From: Clinton Huey <clinthuey@gmail.com>
To: p66-railspur-comments@co.slo.ca.us
Date: 11/23/2014 09:41 PM
Subject: Phillips 66 Rail Terminal Expansion Project

Responses to Clinton Huey Comments

Figure 1. Railroad Accident Rate 2004 – 2014

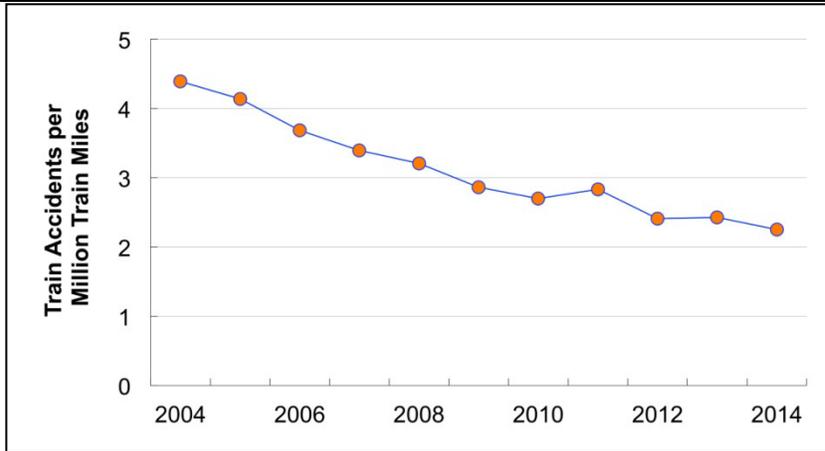
The EIR's worst-case scenario estimates a spill of 180,000 gallons, or roughly six tank cars of crude. This has to be an error because most crude trains have 100 or more tank cars, carrying millions of gallons. Depending upon where an accident occurred, such a spill could devastate our scarce water resources, sensitive ecosystems, schools, homes, transit facilities and rail lines, businesses, and our local economy. In Alameda County, this rail route parallels major highways and urban areas in several cities, including (but not limited to) Berkeley, Oakland, San Lorenzo, and Hayward. In San Leandro, these trains would pass within less than a mile from our City Hall, Police Department, two BART Stations, and the tracks pass through the heart of our downtown.

The railroad accident rate has been steadily trending downward for over a decade. The accident rates in the past few years were the lowest since the FRA started recording the data in the mid-1970s. In the period from 2004 to 2014 the rate declined by 49% (almost half) (see Figure 1 below). Most derailments receive little or no attention from the public or media. Railroads are required by regulation to report all accidents that exceed a certain monetary threshold in damage to track, signals and rolling stock (currently \$9,600). Proper estimation of train accident rates involves analysis of all accidents, divided by the total amount of traffic. The reason that some perceive an increase in the railroad petroleum crude oil accident rate is because of the more than 50-fold increase in this traffic since 2009. Estimates are that 233,698 tank cars of crude oil were moved by rail in 2012. This increased to over 435,000 tank cars moved by rail in 2013 (the full year of data is not yet available for 2014). With this increase in crude by rail traffic, the derailment and spill probability data would suggest that multiple crude by rail accidents would happen each year.

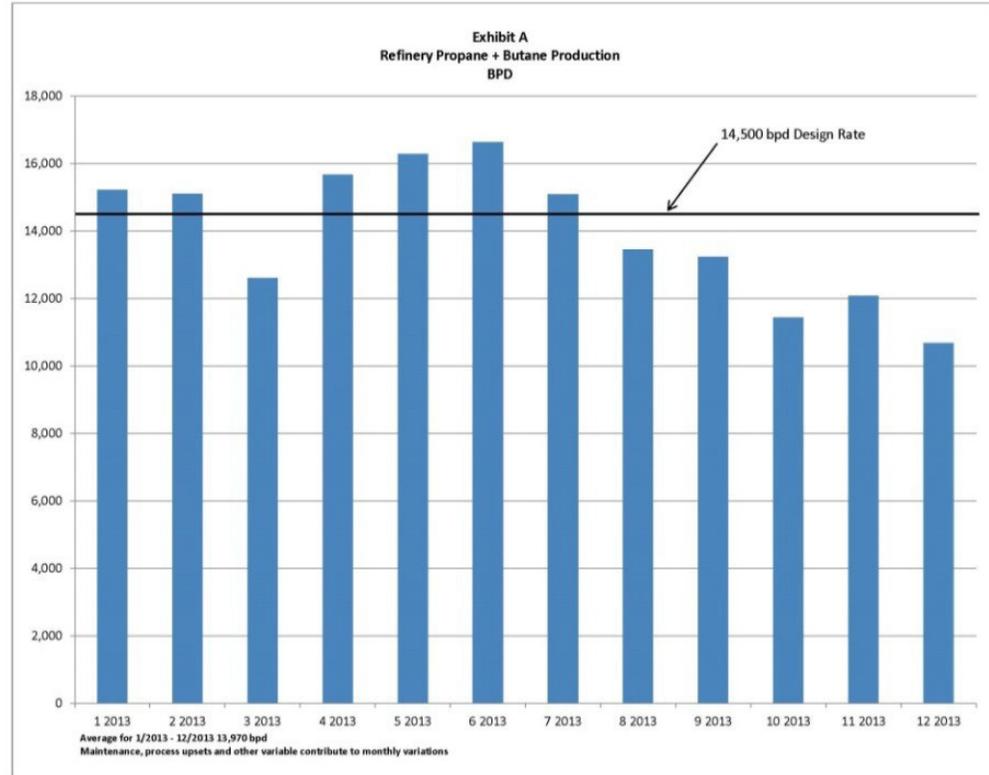
The planning department must examine the cumulative impacts of the Santa Maria and Rodeo proposals as a single project -- not in isolation -- since the proposed terminal in Santa Maria is directly linked by pipeline to the Phillips 66 refinery in Rodeo. Phillips 66 is proposing to modify both facilities to allow it to refine the most toxic crude oil on Earth: Canadian tar sands.

The Propane Recovery Project is designed to remove up to 14,500 barrels of LPGs per day. Data regarding actual LPG content of the RFG is consistent with the design basis for the project. The figure below shows that, for the twelve month period from January through December 2013, the average LPGs in the Rodeo RFG was 13,970 barrels per day.
